Falcon Storage Expansion Transportation Memorandum

AUGUST 12, 2021

LSC #S214430

LSC Responses to Falcon RV Storage -- EPC Redline Comments

Figure 2
Site Plan

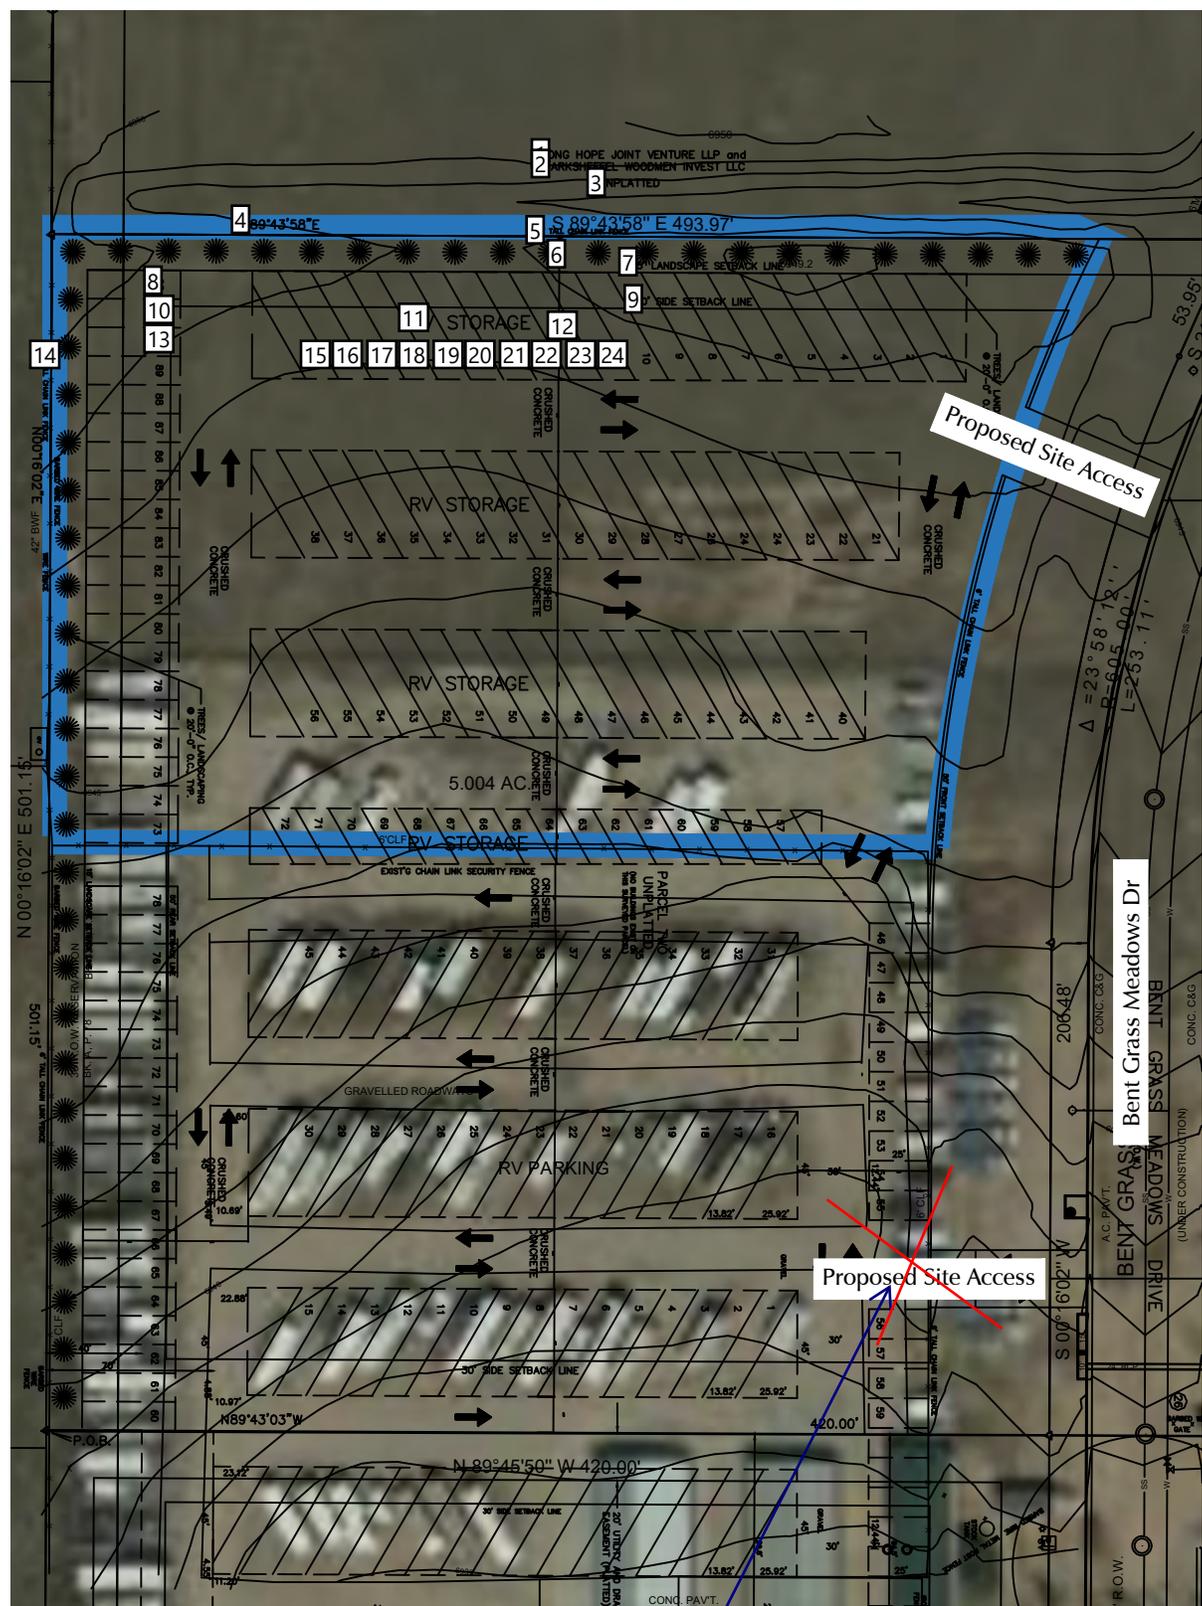
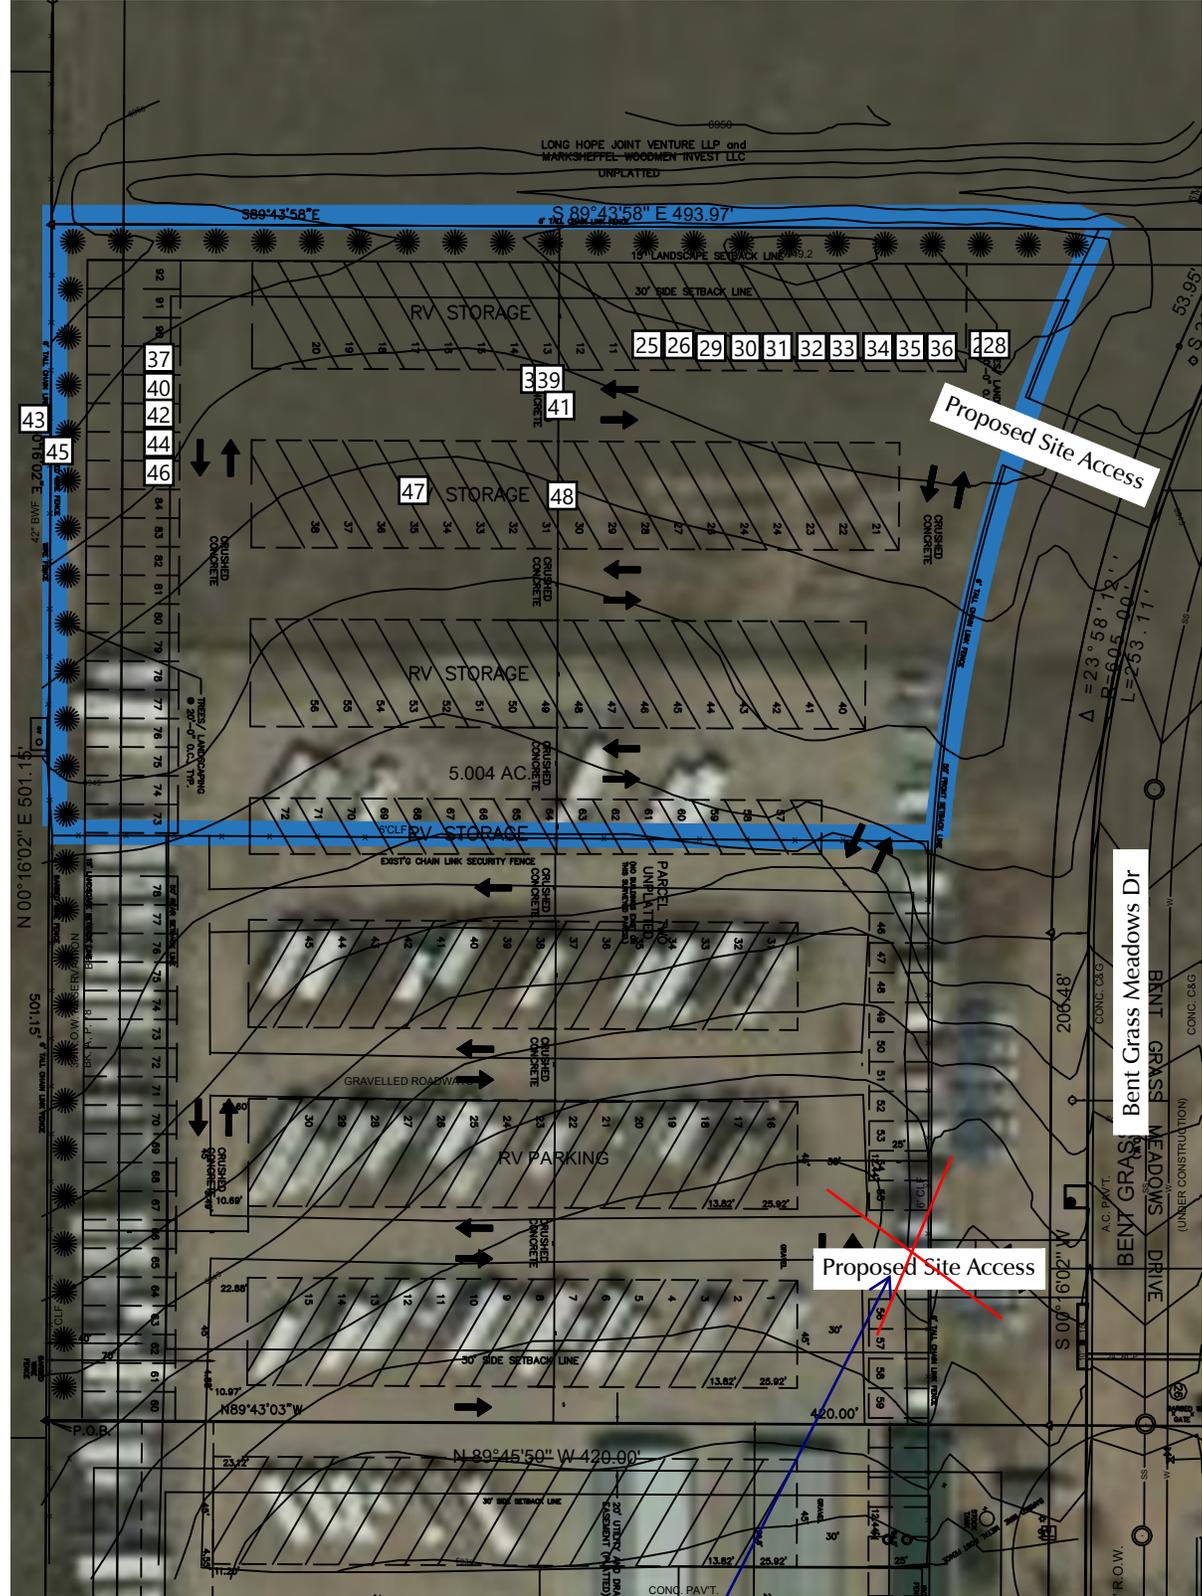
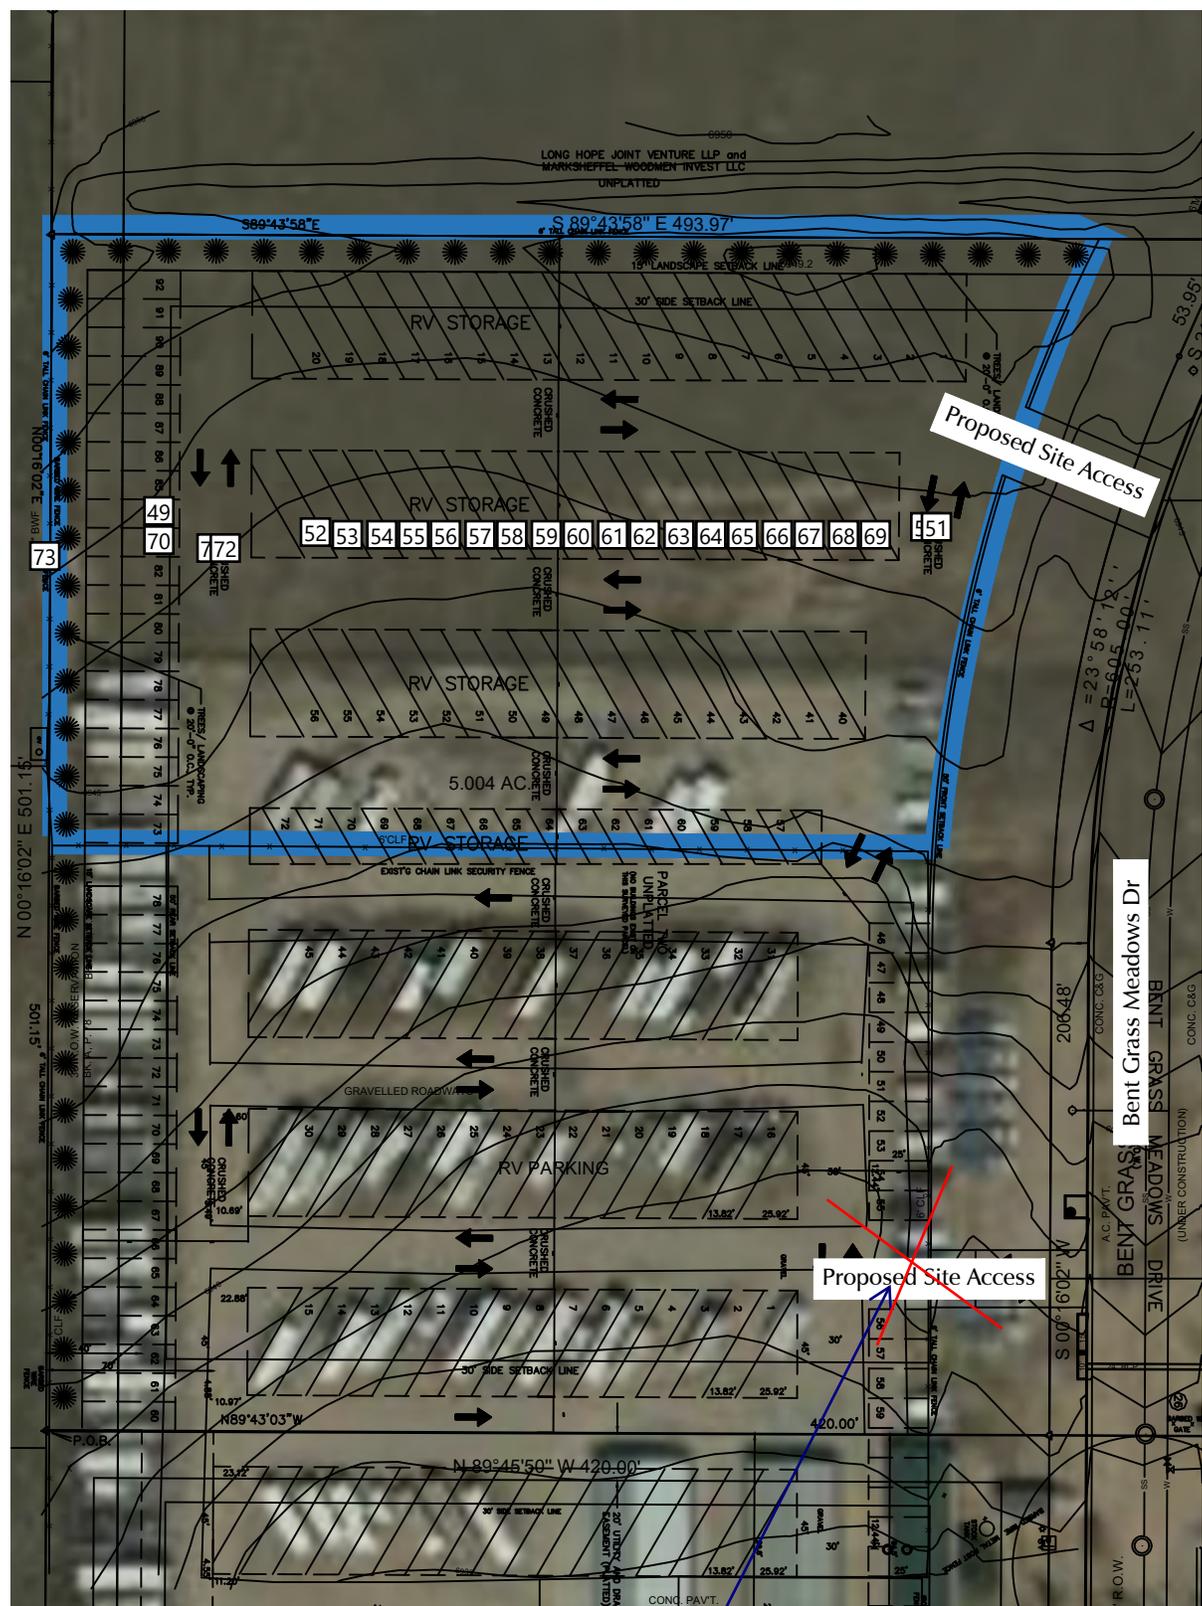
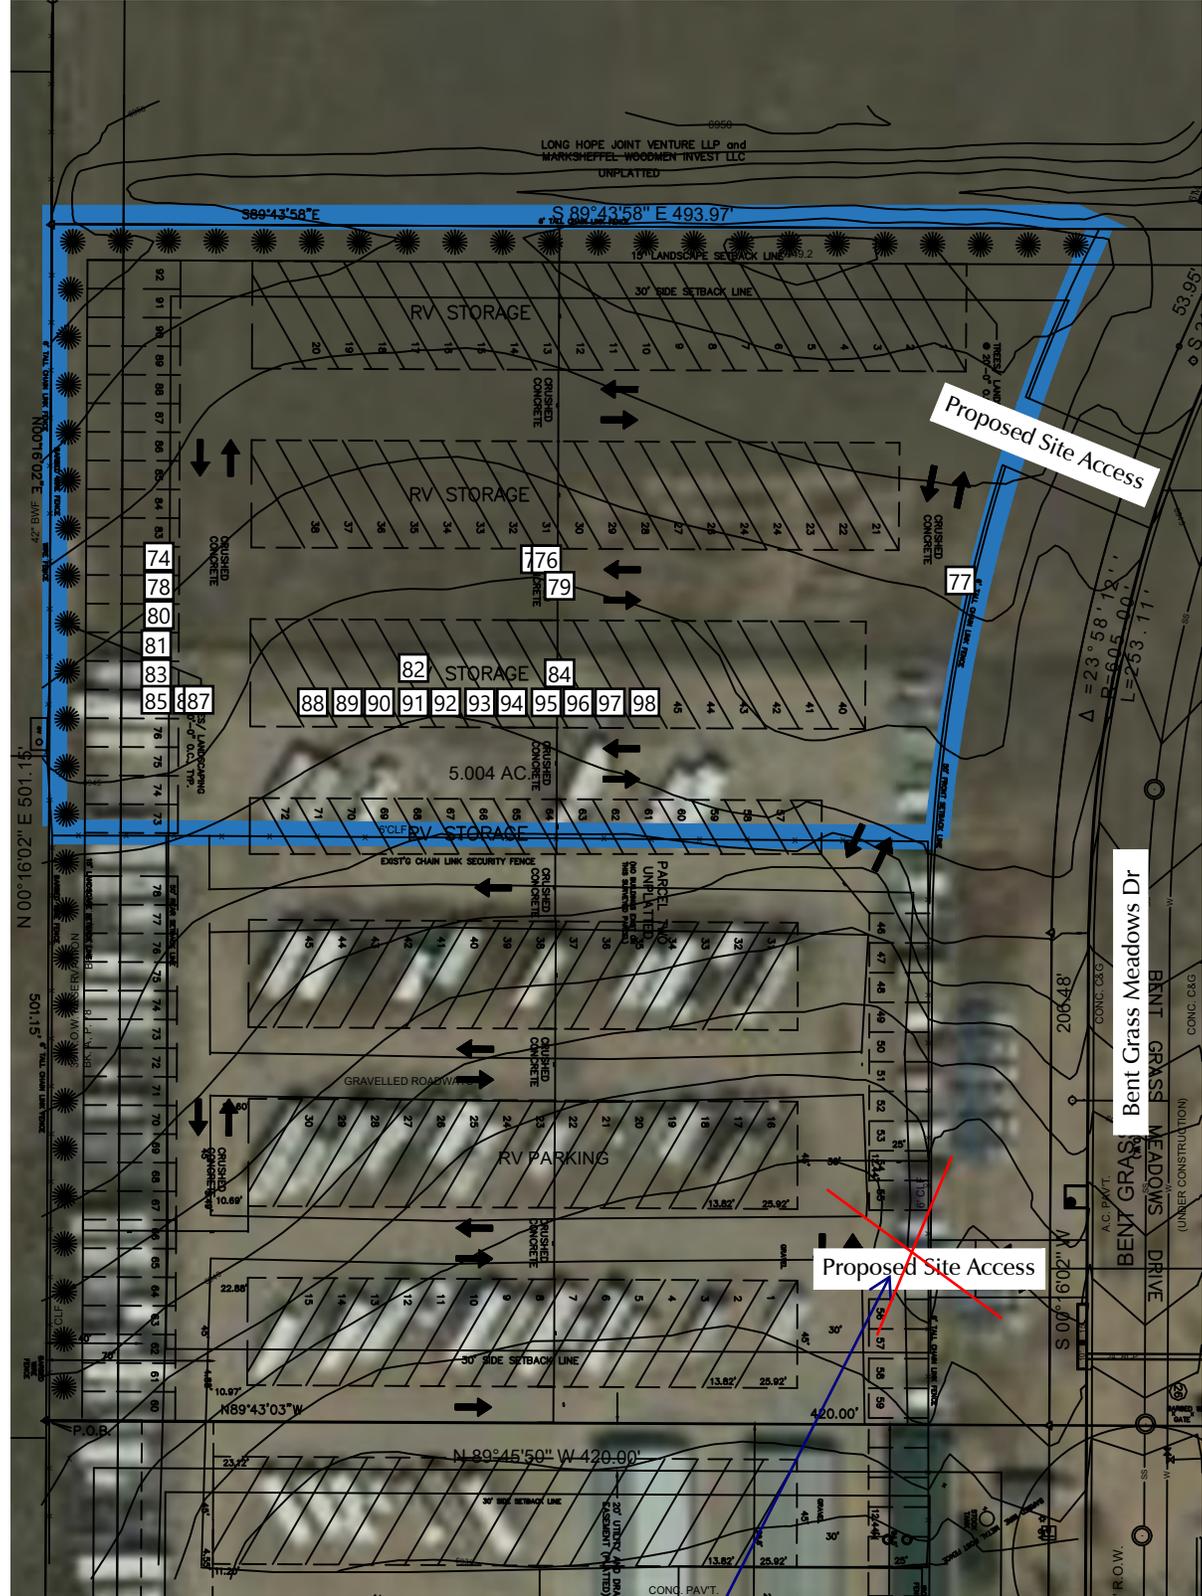
Please update the site plan to match the current proposed plan showing a single new access point

Author: jchodsdon Subject: Sticky Note Date: 7/17/2023 9:18:23 AM
LSC Response: The TIS has been updated accordingly.
